Response to
Request for Additional Information No. 167, Supplement 2

U. S. EPR Standard Design Certification
AREVA NP Inc.
Docket No. 52-020

**SRP Section: 15.06.05 - Loss of Coolant Accidents Resulting From Spectrum of
Postulated Piping Breaks Within the Reactor Coolant Pressure Boundary**

Figure 15.06.05-31-5—Steam Generator Secondary Inventory for 1.5 inch Break

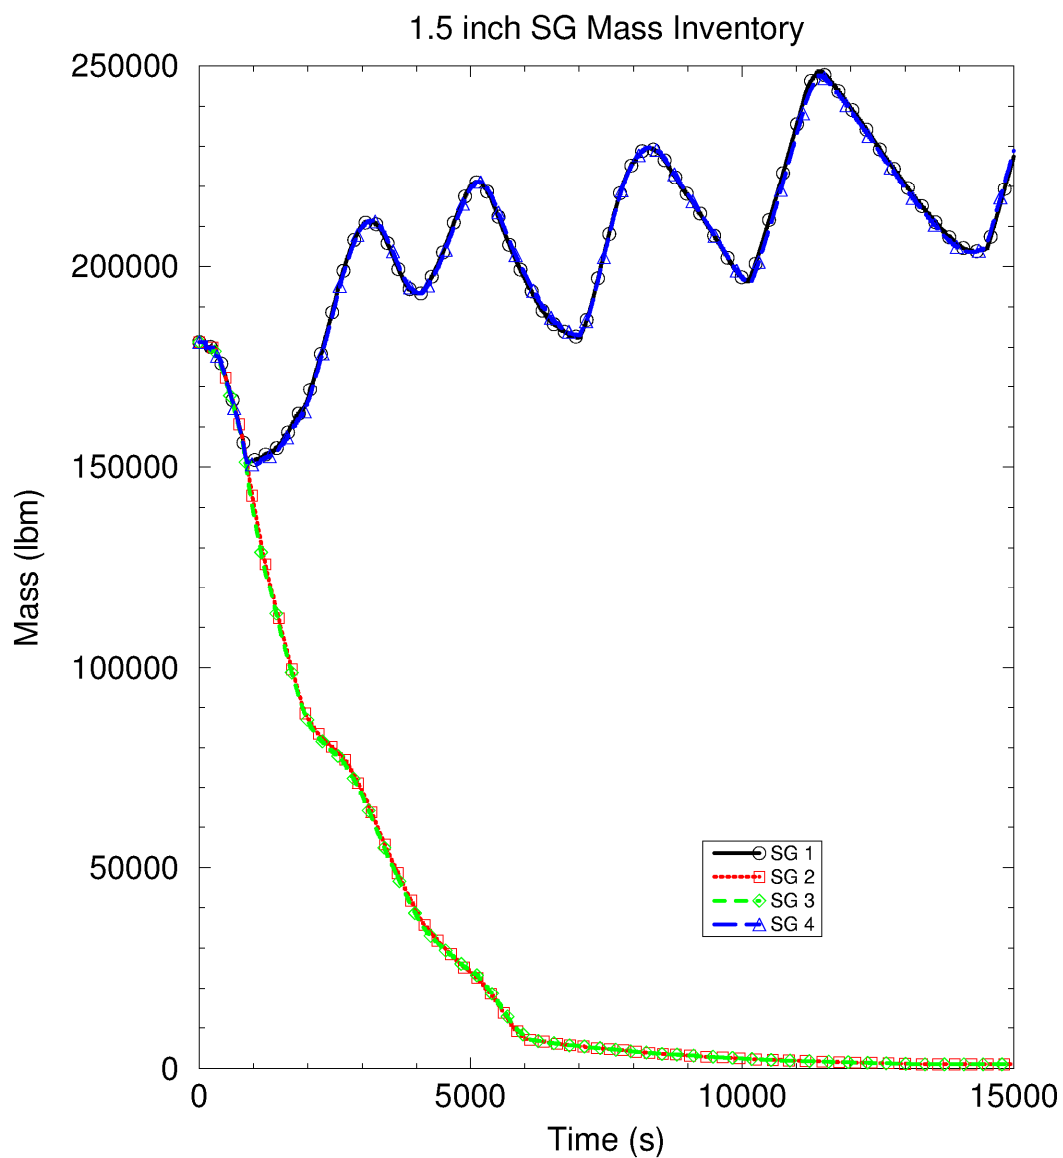
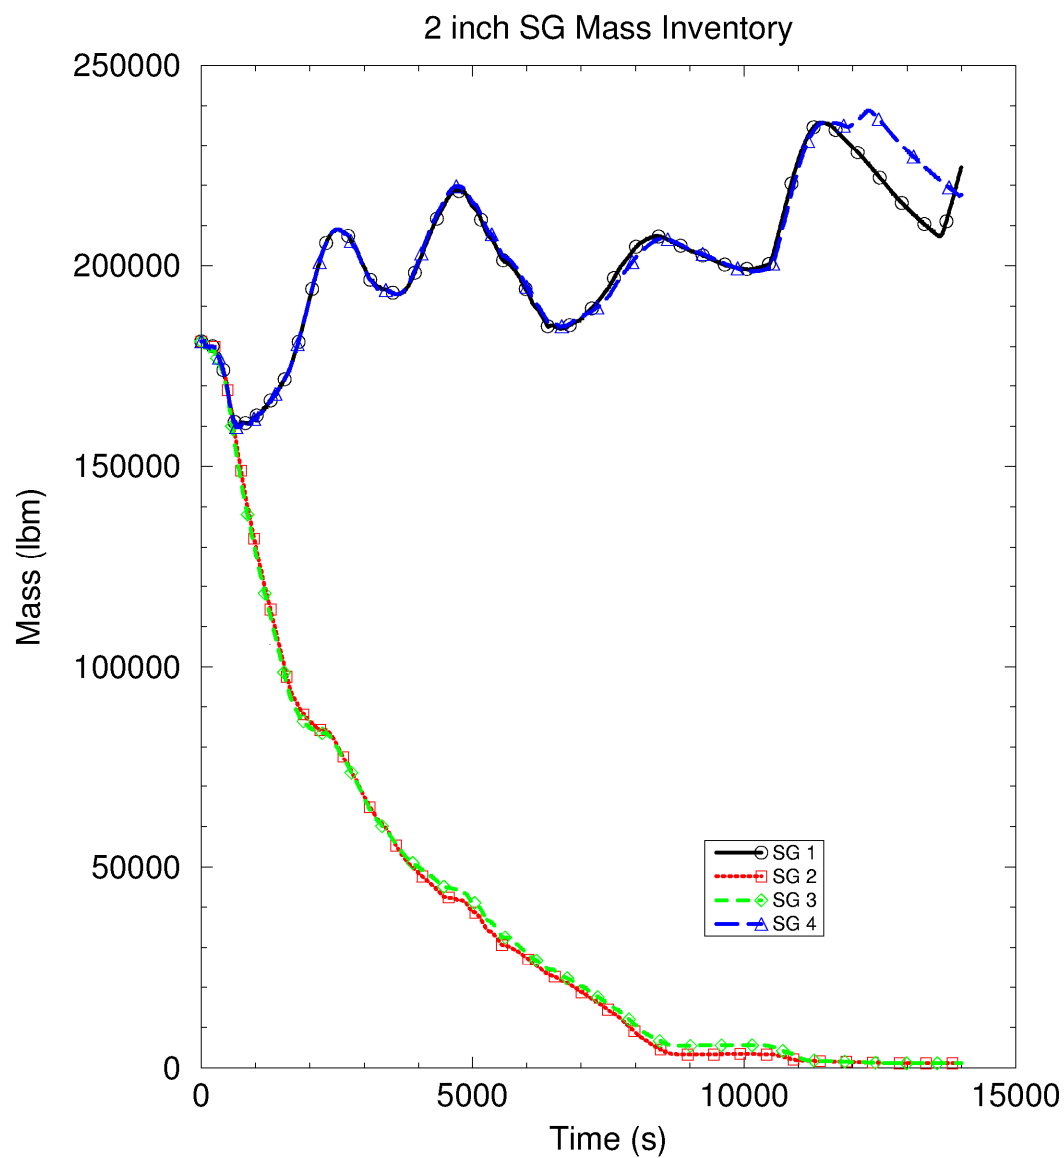
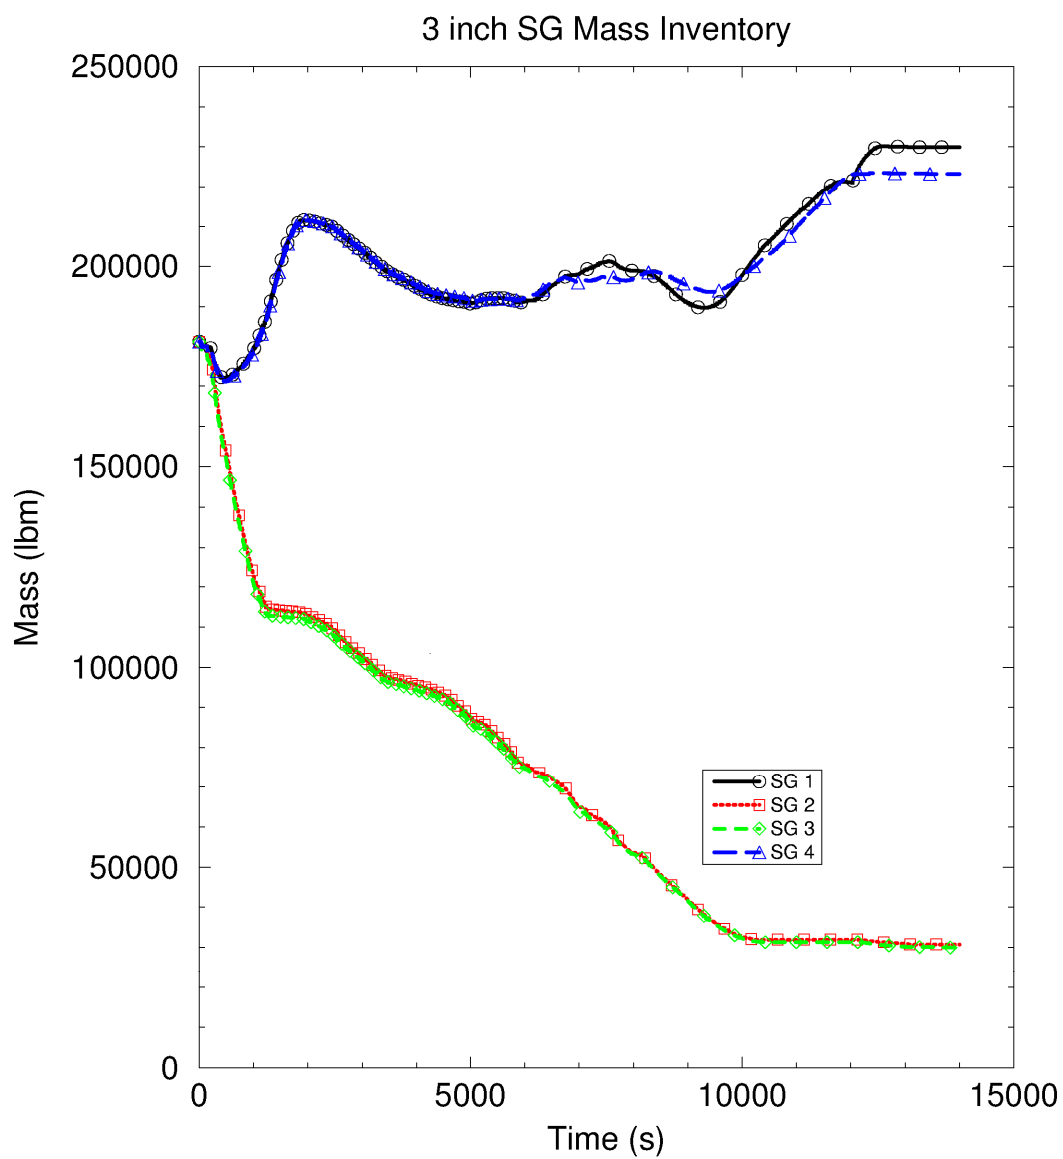
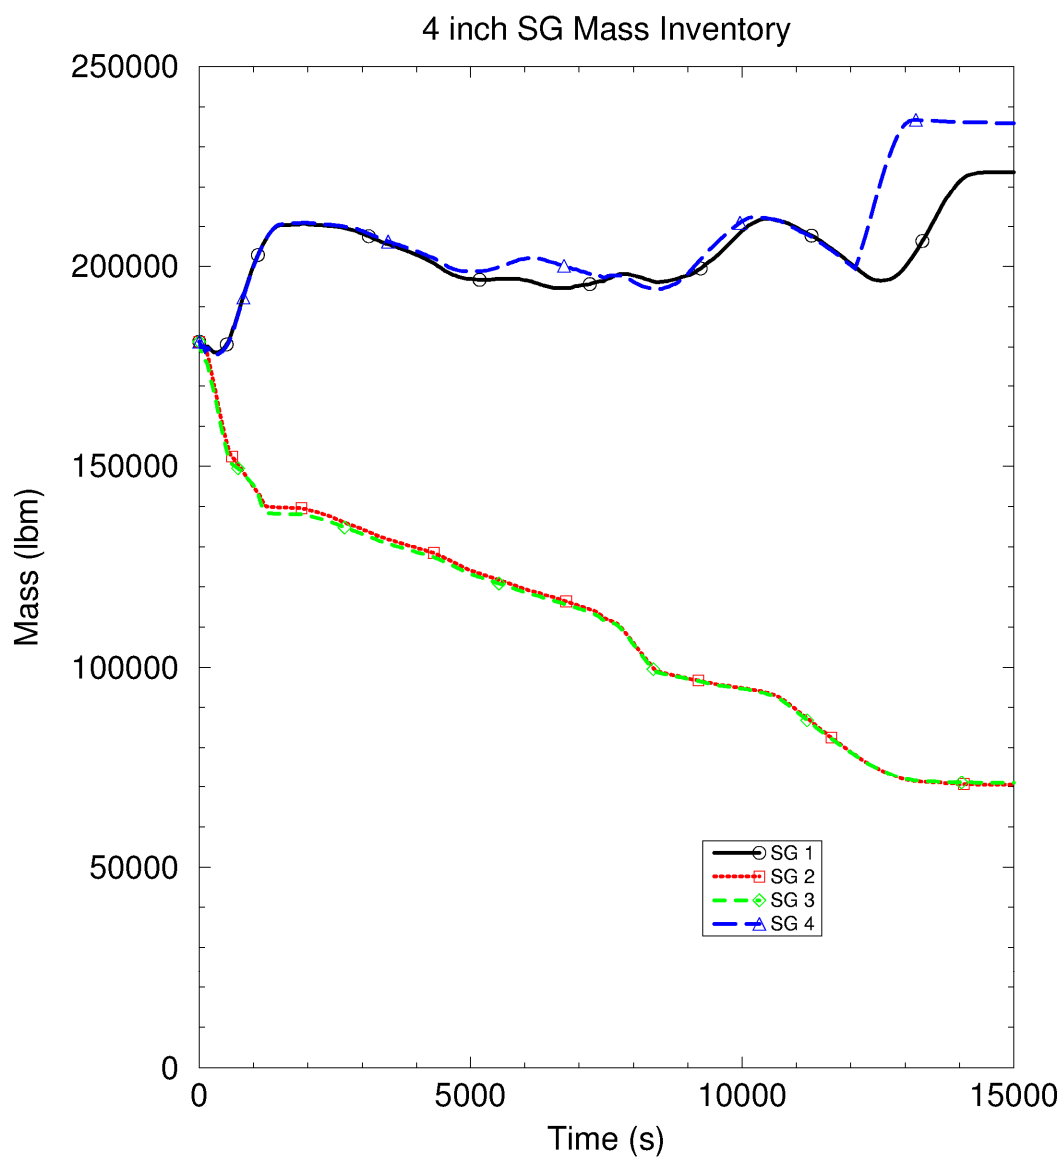
Describe the SG secondary response in terms of pressure, temperature and liquid inventory conditions for each individual SG consistent with the analysis assumptions made, including EFW availability and depressurization considerations.

The water levels in SGs 1 and 4 are controlled by the emergency feedwater (EFW) system. Plots of the SG mass inventory are provided in Figures 15.06.05-31-5 through 15.06.05-31-8. Due to the maintenance of one train and the single failure assumption, EFW is not provided to SG 2 and SG 3, thereby allowing the levels and inventory in those SGs to fall into the tube regions (for the 1.5 inch and 2 inch case these generators dry out; for the 3 inch and 4 inch case some water remains). The plots of the EFW flows are provided in Figures 15.06.05-31-9 through 15.06.05-31-12. The quantity of EFW used by each SG is provided in Table 15.06.05-31-1 for each of the cases analyzed. For each break size the cases were run at least until the end of the operator-initiated 90°F/hr cooldown. The EFW is not exhausted in either of the two EFW trains that operate for any of the break size cases. Furthermore, the U.S. EPR design allows any train pump to take suction from any storage tank and feed any SG. As such, all of the EFW is available for the operators to use as-needed. However, due to the energy lost out the break, the quantity of EFW actually used is adequate and decreases as the break size increases.

Figure 15.06.05-32-1—Pressurizer Pressure and SG 1 Pressure

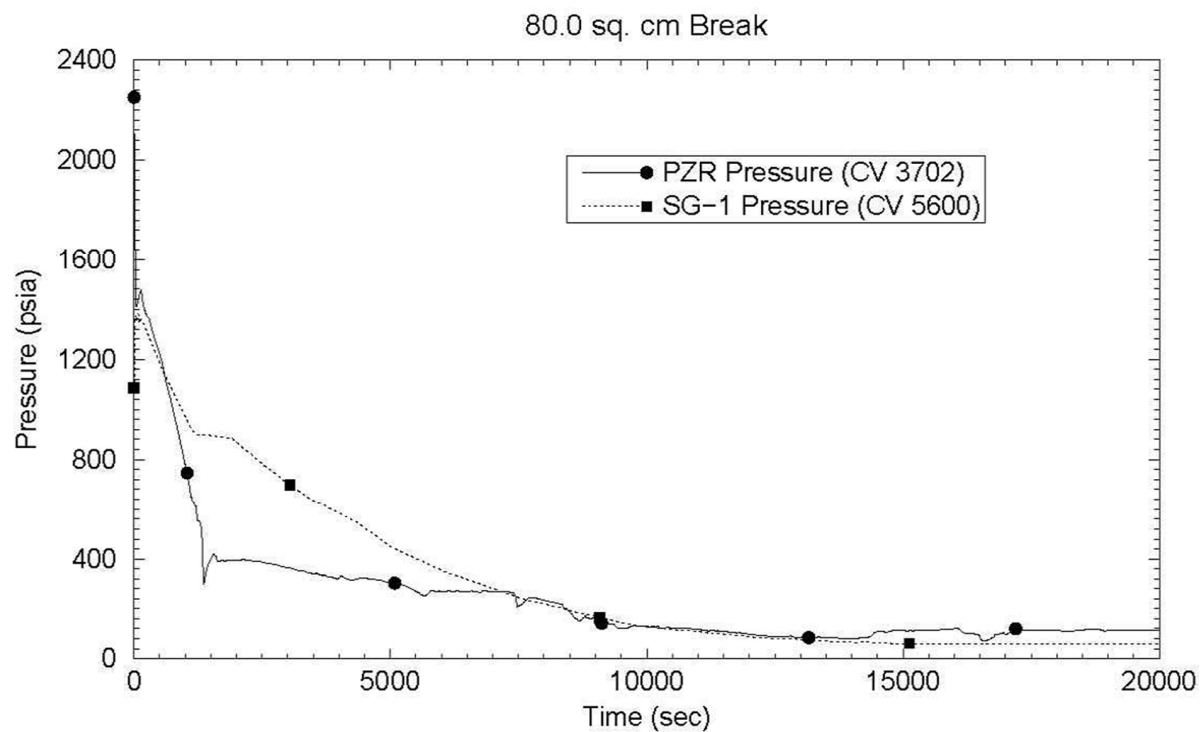
Discuss the sufficiency of the cases analyzed in terms of number of break sizes considered within the break area range and spectrum.

Due to break flow, the 4 inch break depressurizes the primary side faster than the secondary side (see Figure 15.06.05-32-1). With the continued SG cooldown, the secondary pressure drops below the primary system pressure at around 7000 seconds, thus allowing the SGs to begin to cool and potentially condense primary side steam. Between this point and the restart to natural circulation, the MHSI and LHSI are injecting approximately 350 to 700 lbm/s of IRWST water. Assuming all of the decay heat based on the Appendix K model is evaporating saturated water, the evaporation rate would be about 60 lbm/s. Under these conditions the system refill will be initiated. Larger breaks have an even longer period of time before the condensation on the secondary side becomes effective in removing energy from the primary side. At later times, the decay heat will be less and the safety injection will be higher. Thus, the 4 inch case is bounding and larger breaks do not need to be considered for boron dilution.

Figure 15.06.05-36-1—Flow Dynamics Comparison of PKL III F1.1 Test (top) and U.S. EPR 20.0 cm² Break S-RELAP5 Analysis (bottom)

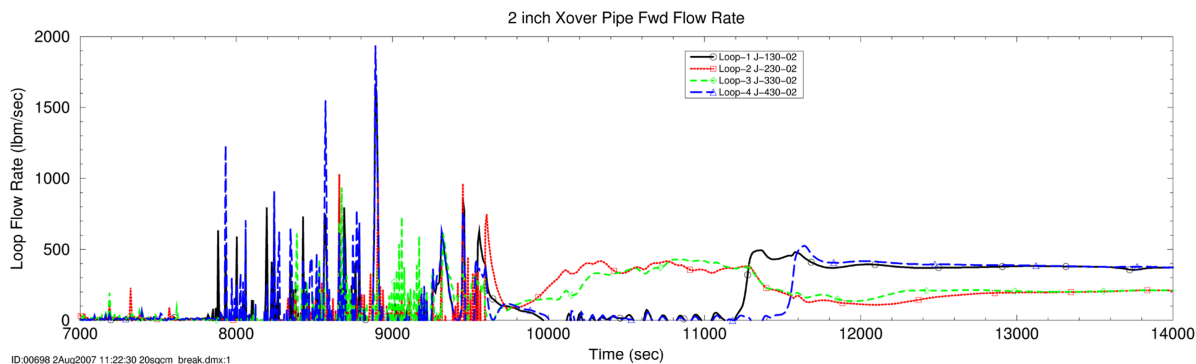
Explain why the qualitative behavior observed in the PKL tests is applicable to the US EPR.

The S-RELAP5 analyses for the evaluation of boron dilution show flow dynamics similar to those observed in the PKL tests after the boiler condenser stage (see Figure 15.06.05-36-1) and thus the boron concentrations should behave in a similar manner. The S-RELAP5 analyses also follow a very similar path for the spectrum of events analyzed; however, the timing for the U.S. EPR is shorter due largely to the higher safety injection rates (48 lbm/s (0.33 lbm/s x 145) for the PKL test vs. 200 lbm/s or higher for the U.S. EPR. The major difference between the PKL F1.1 test and the U.S. EPR is that the U.S. EPR analyses includes the EBS injection flows and the single failure criteria, where safety injection goes into individual loops and emergency feedwater is supplied to the corresponding steam generators. In the PKL test, at about 1835 seconds into the transient the boron concentration in the pump suction increased to about 406 ppm and the SG outlet concentration had not increased. As the backflow continued, the pump suction increased to 900 ppm at 3120 seconds and the SG outlet was beginning to increase as the backflow pushed water into the SG outlet plenum (see Figure 15.06.05-36-2). This backflow behavior in the refill stage is the same as observed in the S-RELAP5 analyses. In addition, the PKL test started with the lower equivalent safety injection boron concentrations and still demonstrated that the concentrations in the bottom of the downcomer will be greater than that required to prevent recriticality.
